## Proposal for 06 series of amendments to UN Regulation No. 46 (Devices for indirect vision)

### Submitted by the Working Party on General Safety Provisions\*

The text reproduced below was adopted by the Working Party on General Safety Provisions (GRSG) at its 126<sup>th</sup> session (ECE/TRANS/WP.29/GRSG/105, para. 9). It is based on ECE/TRANS/WP.29/GRSG/2023/23, as amended by annex III to the report. It is submitted to the World Forum for Harmonization of Vehicle Regulations (WP.29) and to the Administrative Committee (AC.1) for consideration at their March 2024 sessions.

- (i) Edge of the reflecting surface enclosed in a protective housing  
(ii) Reflecting surface projects beyond the protective housing in a specific adjustment position  
(iii) Edge of the reflecting surface not enclosed by the protective housing

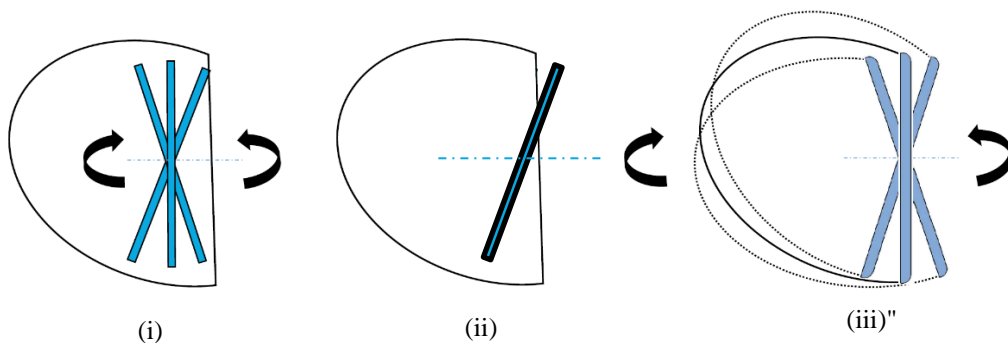
Paragraph 6.1.1.2., amend to read:

When the edge of the reflecting surface is enclosed in a protective housing, the radius of curvature "c" on the housing's perimeter shall be not less than 2.5 mm at all points and in all directions, figure below (i).

When the reflecting surface projects beyond the protective housing in any adjustment position (figure below (ii)), the radius of curvature "c" on the edge of the projecting part shall be not less than 2.5 mm and the reflecting surface shall return into the protective housing under a force of 50 N applied to the point of greatest projection, relative to the protective housing, in a horizontal direction, approximately parallel to the longitudinal median plane of the vehicle.

When the edge of the reflecting surface is not enclosed by the protective housing independent from any adjustment position, the radius of curvature "c" on its perimeter shall be not less than 2.5 mm at all points and in all directions and shall apply to the edge of the projecting part, figure below (iii).

"Figure 9.1

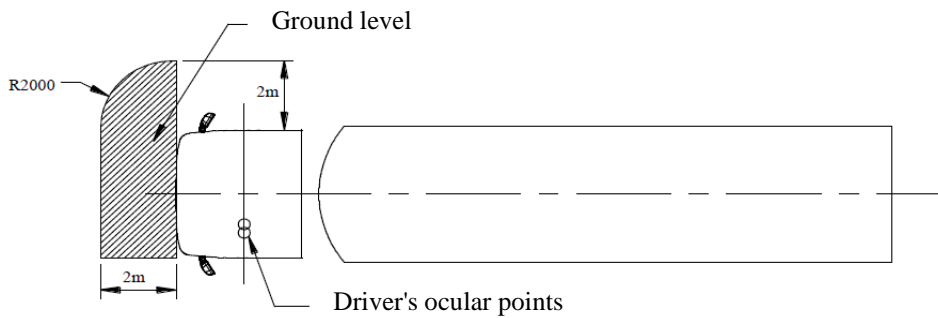
"15.2.4.6.1. The field of vision shall be such that the driver can see at least a flat horizontal portion of the road, which is for side-steered vehicles bounded by:

- (a) A transverse vertical plane through the outermost point of the front of the vehicle;
- (b) a transverse vertical plane 2,000 mm in front of the plane defined in (a);
- (c) a longitudinal vertical plane parallel to the longitudinal vertical median plane going through the outermost side of the vehicle at the driver's side;
- (d) a longitudinal vertical plane parallel to the longitudinal vertical median plane 2,000 mm outside the outermost side of the vehicle opposite to the driver's side; and
- (e) the front of this field of vision opposite to the driver's side may be rounded off with a radius of 2,000 mm (see Figure 9.1).

Figure 9, renumber as Figure 9.1. and amend to read:

"Figure 9.2  
Class VI field of vision for centre-steered vehicle"

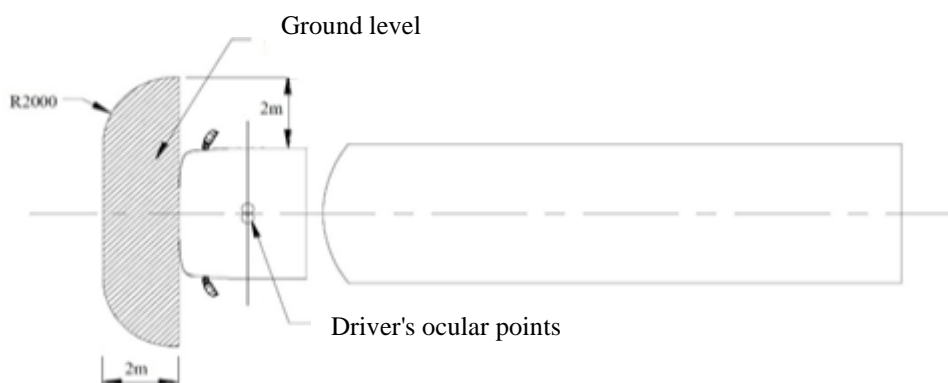
The field of vision shall be such that the driver can see at least a flat horizontal portion of the road, which is for centre-steered vehicles bounded by:

- (f) A transverse vertical plane through the outermost point of the front of the vehicle;
- (g) a transverse vertical plane 2,000 mm in front of the plane defined in (a);

- (h) a longitudinal vertical plane parallel to the longitudinal vertical median plane 2,000 mm outside the outermost side of both sides of the vehicle; and
- (i) the front of this field of vision on both sides may be rounded off with a radius of 2,000 mm (see Figure 9.2).

Insert a new figure 9.2., to read:

### **Arrangement of approval mark of a device for indirect vision**

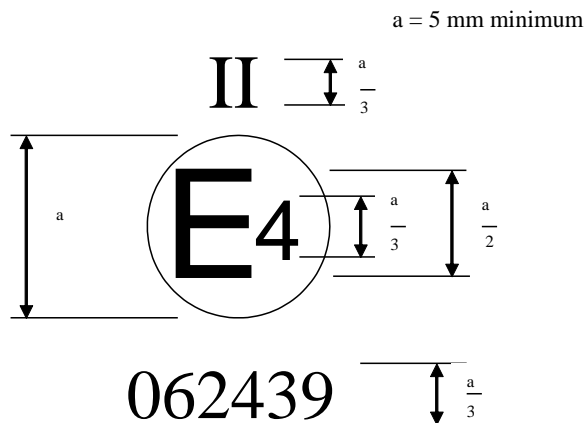
*Annex 5*, amend to read:

The above approval mark affixed to a device for indirect vision indicates that the device is a main rear-view device, of Class II, which has been approved in the Netherlands (E 4) pursuant to Regulation No. 46 and under approval number 062439. The first two digits of the approval number indicate that Regulation No. 46 already included the 06 series of amendments when the approval was granted.

"Figure 1

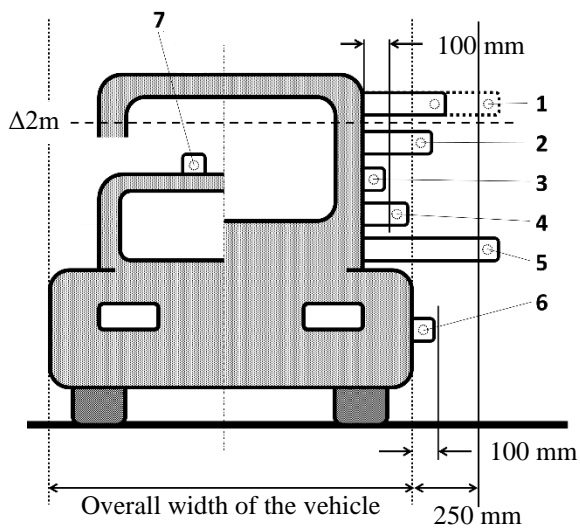
Annex 9, amend to read:

PENDULUM IMPACT TEST
	<u>Device for indirect vision CLASS II-VII</u>
1	NO TEST (15.2.2.6.)
2	COMPULSORY
3	NO TEST (6.3.2.b))
4	NO TEST (6.3.2.a))
5	not permitted (15.2.2.6.)
6	NO TEST (6.3.2.b))
	<u>Camera of CLASS I (CMS)</u>
7	NO TEST (6.3.2.b)
